Access Compliance Report

Public Rights-of-Way

Intersection ID: 46693	Main Street: GOLDFIELDS_DR	Cross Street: OLD_MEADOW_RD	Location: NE
ADA ID: 1B9A12E0CBBB	Ramp Type: PerpDiag	Initial Pass/Fail: Fail	Overall Compliance: No
			Severity Score: 13.75

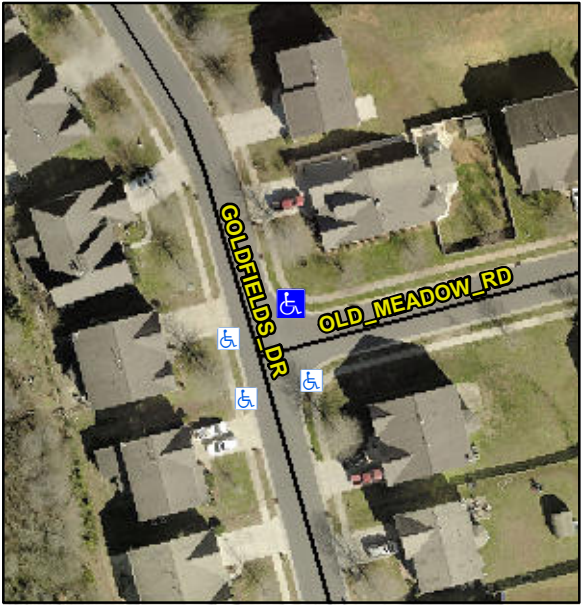
Codes/Mitigation Info/Possible Solution		Field Measurements/Component Compliance					
	Possible Solutions:						
	Remove & Replace Curb Ramp With Two New Directional Ramps or Equivalent.						
	Surveyor Notes:						
	N/A						
	PROW/ADA:						
	Not Found, R304.2.2, R304.5.3						
		Compliance	Description	Data	Compliance	Description	Data
		N/A	Ramp Length (in)	46.5	No	Ramp Slope (%)	9.1
		Yes	Ramp Width (in)	48.0	No	Ramp XSlope (%)	2.4
		N/A	Flare Type LT	N/A	N/A	Flare Type RT	N/A
		N/A	Flare Slope LT (%)	N/A	N/A	Flare Slope RT (%)	N/A
		N/A	Flare Traversable LT?	N/A	N/A	Flare Traversable RT?	N/A
		N/A	Landing Length (in)	N/A	N/A	DWS Provided?	N/A
		N/A	Landing Width (in)	N/A	N/A	DWS Contrast?	N/A
		N/A	Landing Slope (%)	N/A	N/A	DWS Length (in)	N/A
		N/A	Landing X Slope (%)	N/A	N/A	DWS Full Width?	N/A
		N/A	Landing Curb? (Y/N)	N/A	N/A	DWS Offset (in)	N/A
		N/A	Shared Landing?	N/A			
		N/A	Gutter Ponding?	N/A	N/A	Gutter Slope (%)	N/A
